# ATmega48A/PA/88A/PA/ 168A/PA/328/P

## Silicon Errata and Data Sheet Clarifications

# 32-Lead Thin Plastic Quad Flat, No Lead Package (S4B) - 5x5 mm Body [VQFN] Punch Singulated; 3.10x3.10 mm Exposed Pad

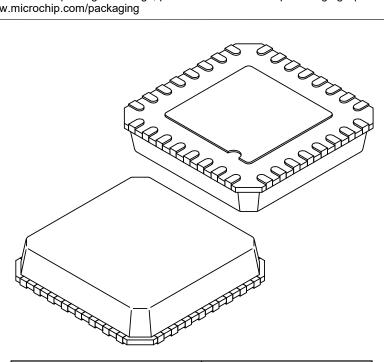
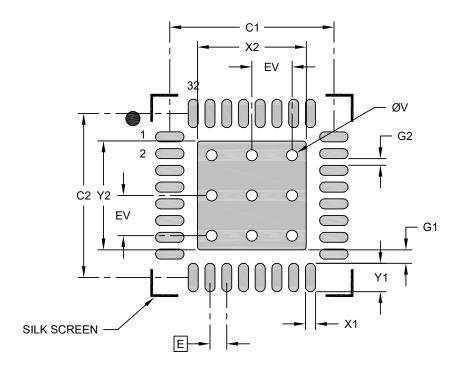
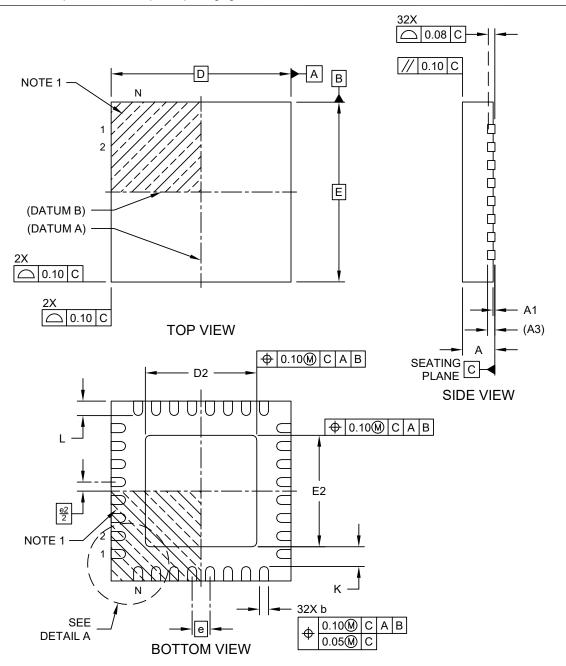
This package type can be delivered with two different styles with reference numbers 'C04-21400' (punched) and 'C04-21395' (sawn) as shown in section 3.2.1 - 32M1-A. For PCB layouts, it is recommended to take both recommended land patterns into consideration.

A clarification about the other package style available for package type 32M1-A has been added to the 32M1-A section.
